CHAIN LINK FENCING FOR CARROLL COUNTY RECREATION DEPARTMENT

The Carroll County Board of Commissioners submits Addendum 1 to Solicitation No. 09-A017, **CHAIN LINK FENCING FOR CARROLL COUNTY RECREATION DEPARTMENT**. In an effort to clarify Specifications, Conditions and Terms the following changes or additions are made to the original Request for Proposal (RFP). Also, Section E has been deleted and Sections H and I are added.

Attachment #1

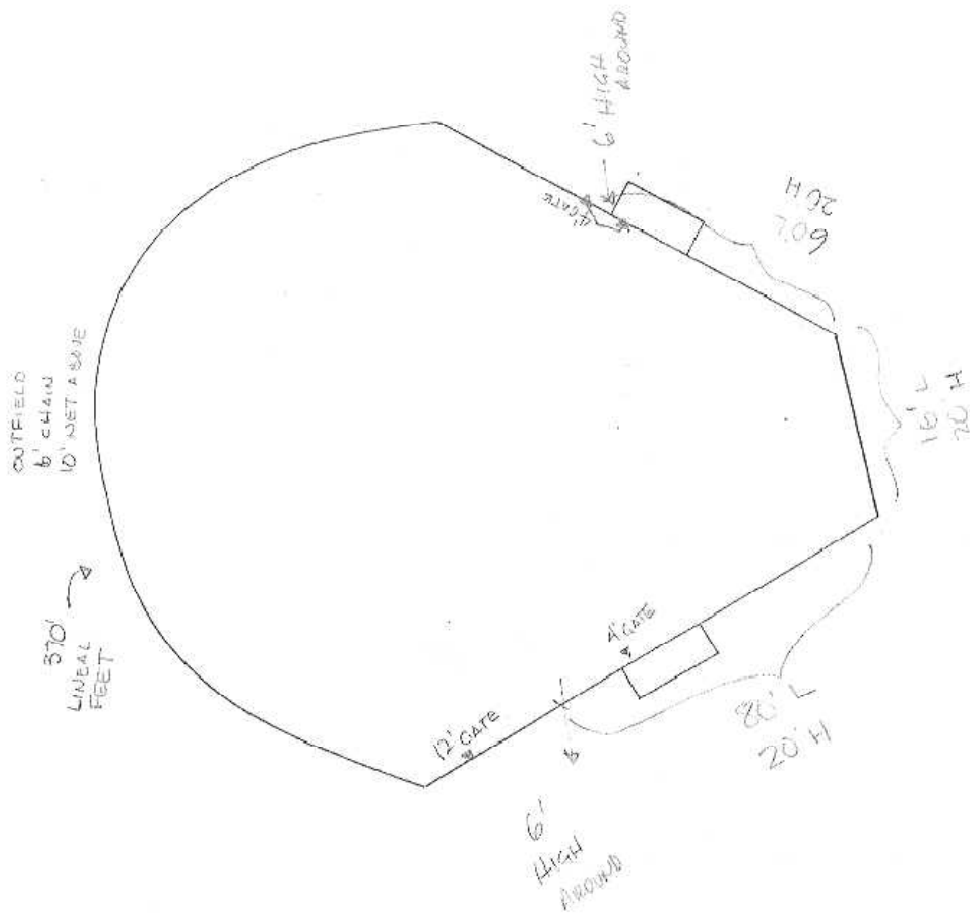
1. PART A (Irrigation Pond Gate) - New Part A: Install approximately two hundred (200) lineal feet of fencing to match existing material, running along shore line of Irrigation Pond to the existing Pump House. Fence posts anchored in concrete spaced no more than ten (10) feet apart, beginning at the existing terminal post and terminating at the Pump House (to the left of electrical panel). Install a twenty (20) feet vehicle gate, and approximately eight (8) feet of fencing, between Pump House and existing retaining wall (railroad ties). See attachment (1) for lay-out.

2. PART B (Soccer Concession Gate) – Fence will begin at corner post of the existing fence (corner of Irrigation Pond) and run two hundred and seventy (270) linear feet terminating at the existing retaining wall (railroad ties). Fence shall match existing fence. This stretch of fence will contain a twelve (12) foot vehicle gate. See attachment (1) for lay-out.

attachment #2

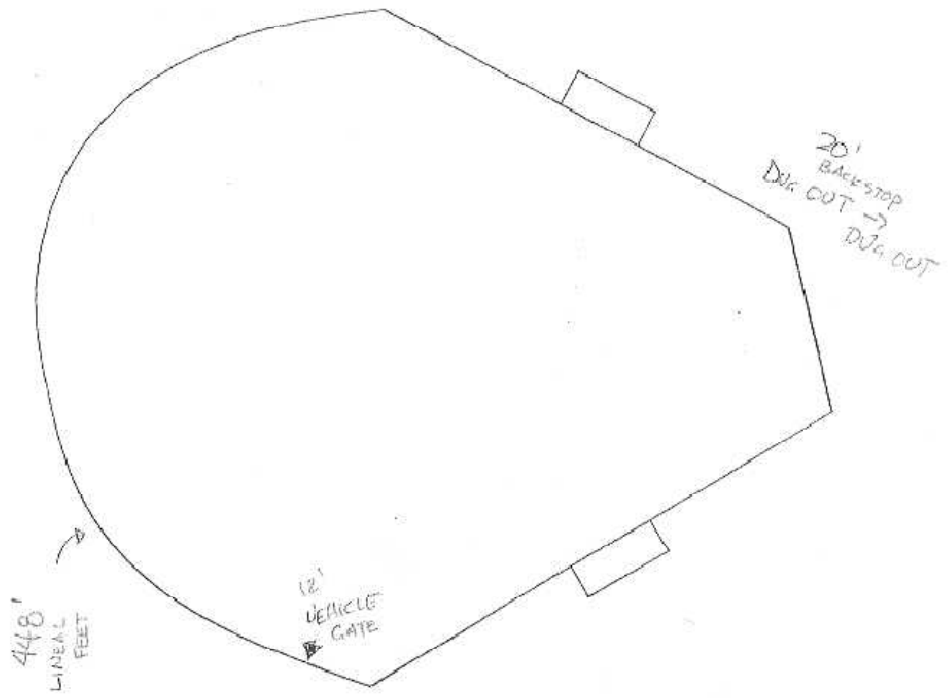
5. PART E (Retention Pond Repair) - Delete entire section.
6. PART F (200' Field) - Make changes in backstop and fencing (height and linear footage) to reflect measurements shown on attachment (2) of this addendum.

Attachment # 4

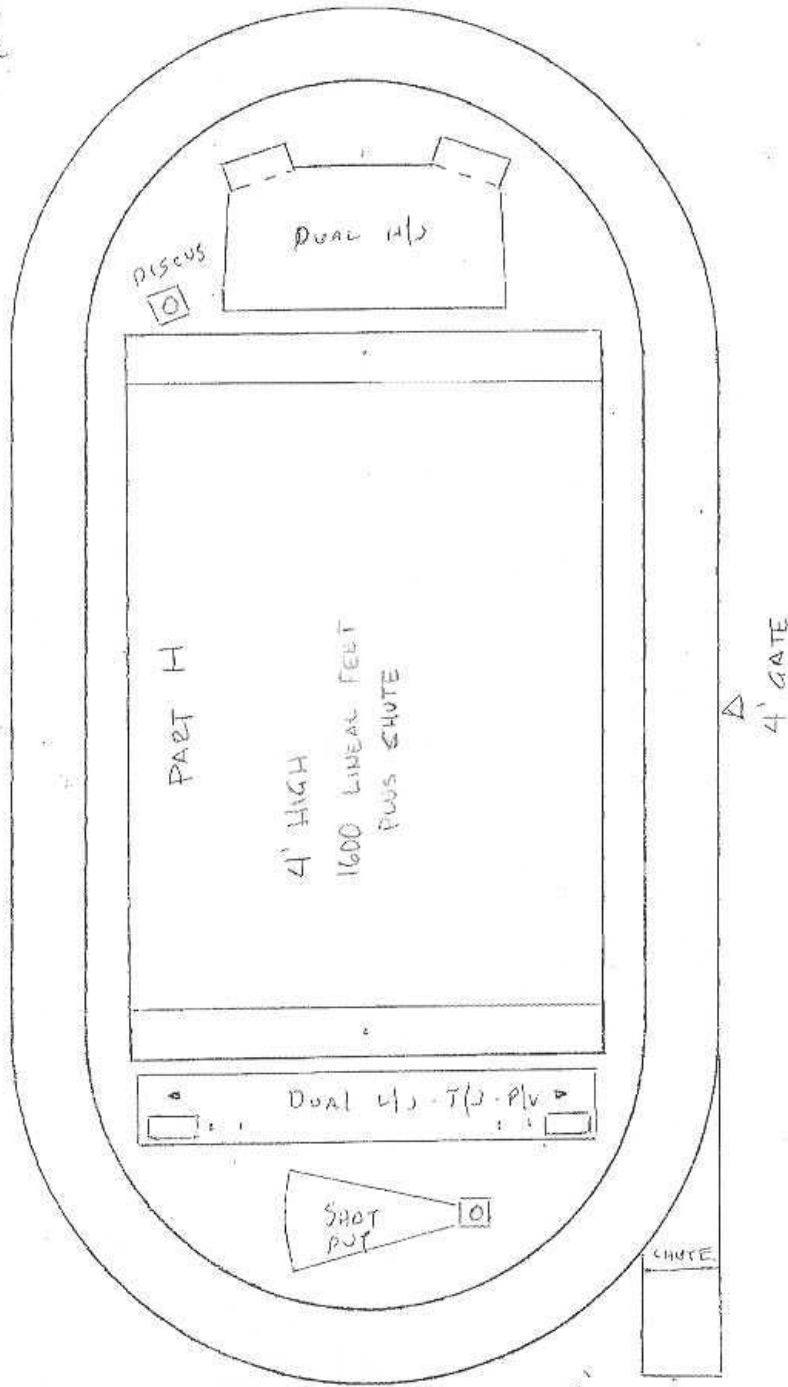
8. PART H (Track Fencing) - **NEW.** Add this project to RFP. Install approximately sixteen hundred (1600) feet of four (4) foot high fencing around track with a four (4) foot walk-through gate. This will include enough fencing to include the chute area. Fence will be nine gauge. See attachment (4) of this addendum for lay-out.
